July 11, 2022

RE: Engineering Analysis for NFPA 285 Compliance of Exterior Wall Assembly at Steamboat
Basecamp Area (Phase 1B), Steamboat Springs, CO
Jensen Hughes Project No. 1AJP22016.000

Figure 1. Exterior wall assembly construction (Detail 4 on Drawing A0902)

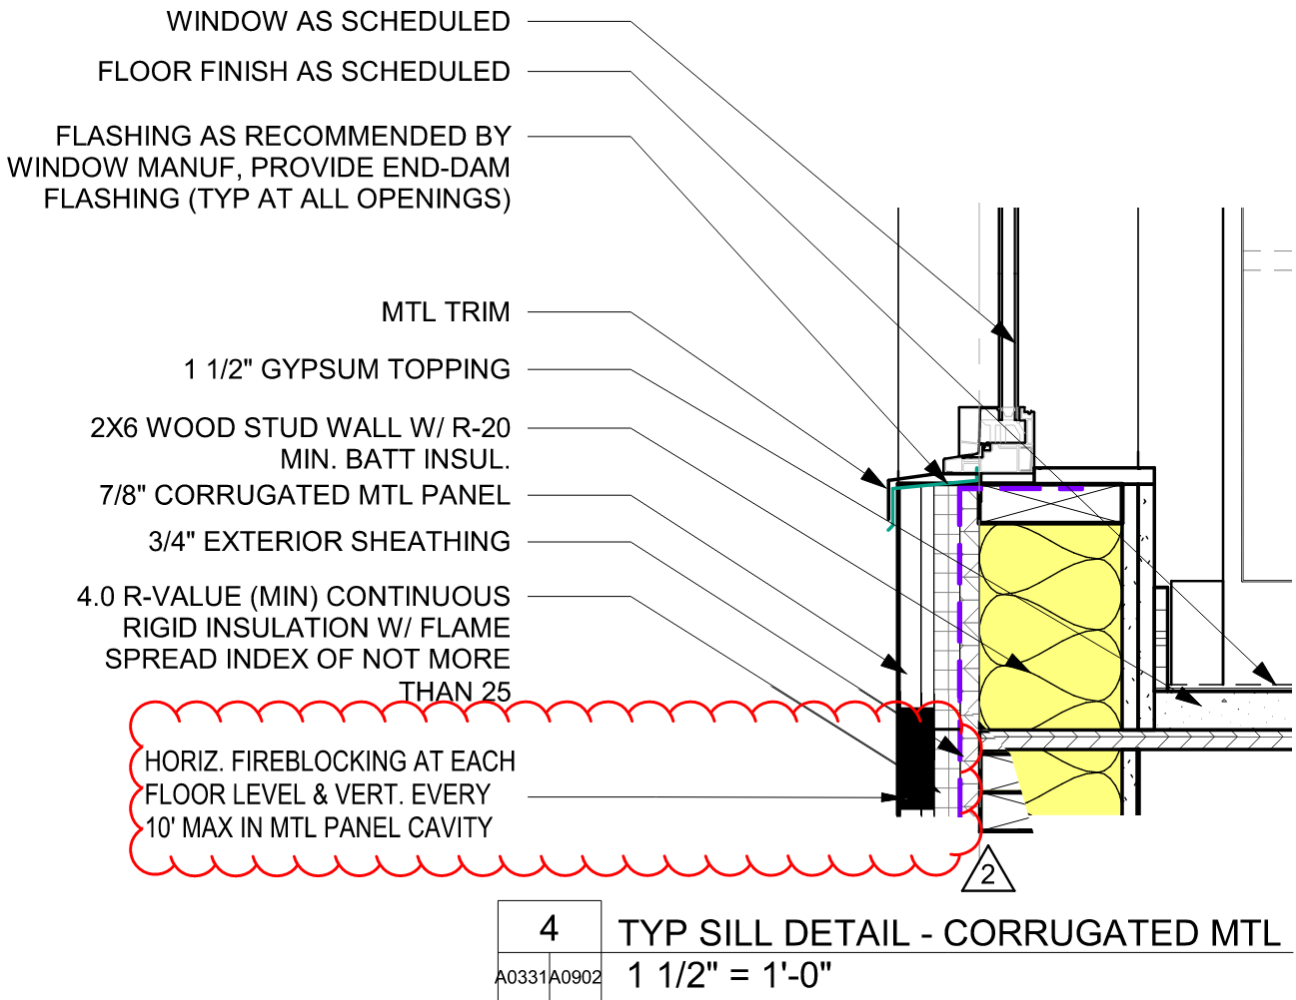
opinion that the exterior LP FlameBlock product must be covered by a minimum ½-inch thick exterior gypsum sheathing applied directly over the exterior face of the LP FlameBlock product with no air gap in between.

(Note: 1/2-inch thick exterior gypsum wallboard over LP Flameblock required for NFPA 285 compliance is not shown in detail)

being protected with a minimum ½-inch thick layer of exterior gypsum sheathing material to provide protection to the underlying combustible product as no NFPA 285 fire performance testing data is available for exterior walls incorporating the LP FlameBlock product.
